WOODMEN HILLS METROPOLITAN DISTRICT
LIFT STATION #1 REPLACEMENT
LANDSCAPING PLAN & NOTES

100% DESIGN DRAWINGS

Markup Summary

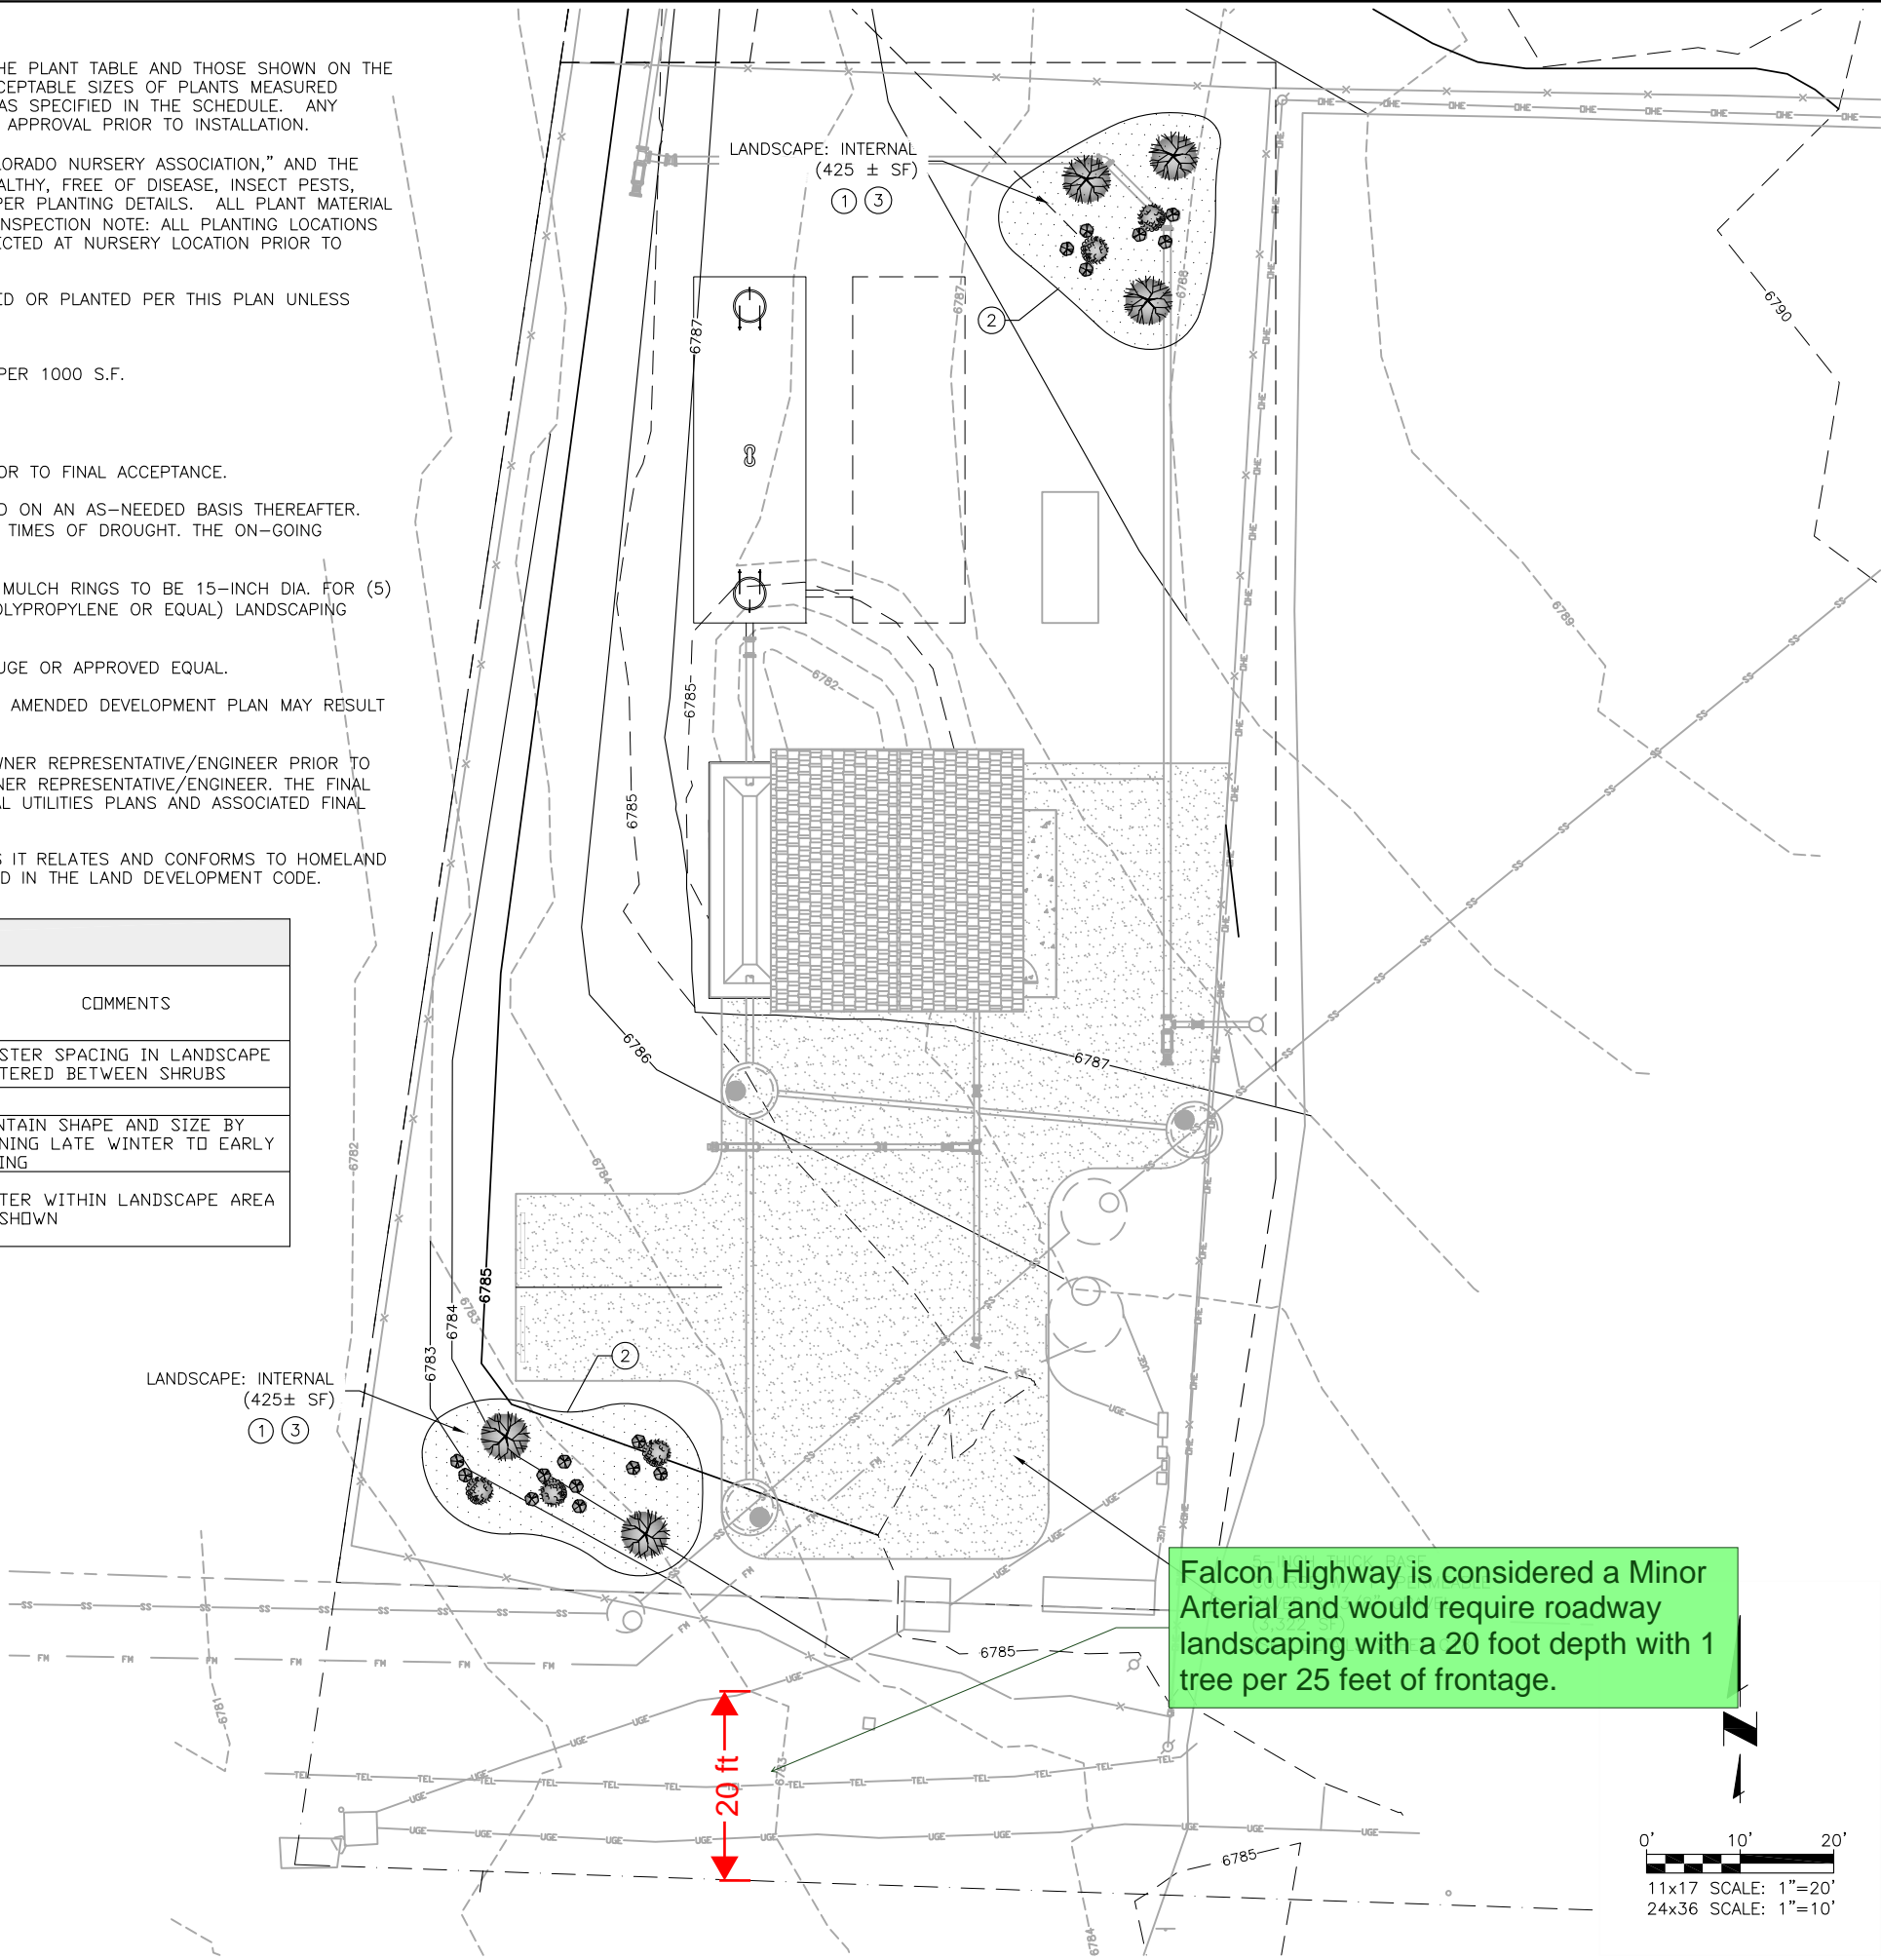
Falcon Highway is considered a Minor Arterial and would require roadway landscaping with a 20 foot depth with 1 tree per 25 feet of frontage.
